Access Compliance Report

Public Rights-of-Way

(Curb Ramps)

Intersection ID: 3273	Main Street: BILLINGHAM_DR	Cross Street: PROSPERITY_CHURCH_RD	Location: SE
ADA ID: 425E832145B5	Ramp Type: PerpDiag	Initial Pass/Fail: Fail	Overall Compliance: No
Severity Score: 22.5			
Codes/Mitigation Info/Possible Solution		Field Measurements/Component Compliance

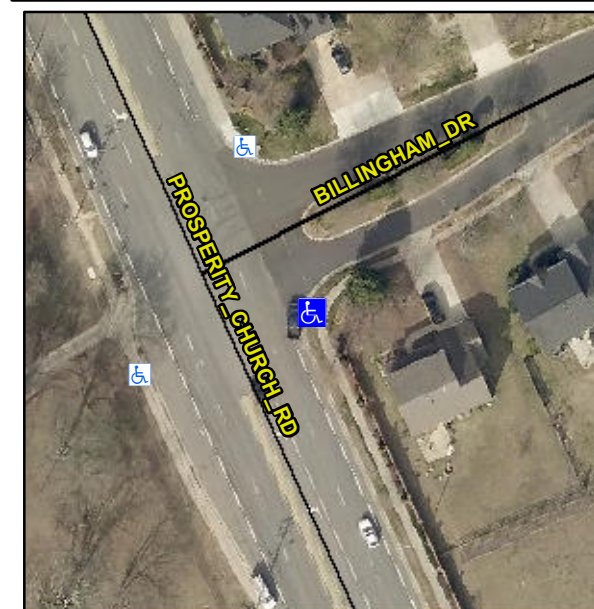
R304.5.1, R304.2.2, R304.5.3

Compliance	Description	Data	Compliance	Description	Data
N/A	Ramp Length (in)	72.0	No	Ramp Slope (%)	8.7
No	Ramp Width (in)	38.0	No	Ramp XSlope (%)	4.8
N/A	Flare Type LT	N/A	N/A	Flare Type RT	N/A
N/A	Flare Slope LT (%)	N/A	N/A	Flare Slope RT (%)	N/A
N/A	Flare Traversable LT?	N/A	N/A	Flare Traversable RT?	N/A
N/A	Landing Length (in)	N/A	N/A	DWS Provided?	N/A
N/A	Landing Width (in)	N/A	N/A	DWS Contrast?	N/A
N/A	Landing Slope (%)	N/A	N/A	DWS Length (in)	N/A
N/A	Landing X Slope (%)	N/A	N/A	DWS Full Width?	N/A
N/A	Landing Curb? (Y/N)	N/A	N/A	DWS Offset (in)	N/A
N/A	Shared Landing?	N/A			
N/A	Gutter Ponding?	N/A	N/A	Gutter Slope (%)	N/A
N/A	Gutter Lip Ht (in)	N/A	N/A	Gutter X Slope (%)	N/A
N/A	Painted X Walk1?	No	N/A	Painted X Walk2?	No
	X Walk 1 Direction	To N		X Walk 2 Direction	To W
N/A	X Walk 1 Width (in)	N/A	N/A	X Walk 2 Width (in)	N/A
	X Walk 1 Slope (%)	1.0		X Walk 2 Slope (%)	5.5
	X Walk 1 X Slope (%)	5.8		X Walk 2 X Slope (%)	0.9

Remove & Replace Curb Ramp With Two New Directional Ramps or Equivalent.
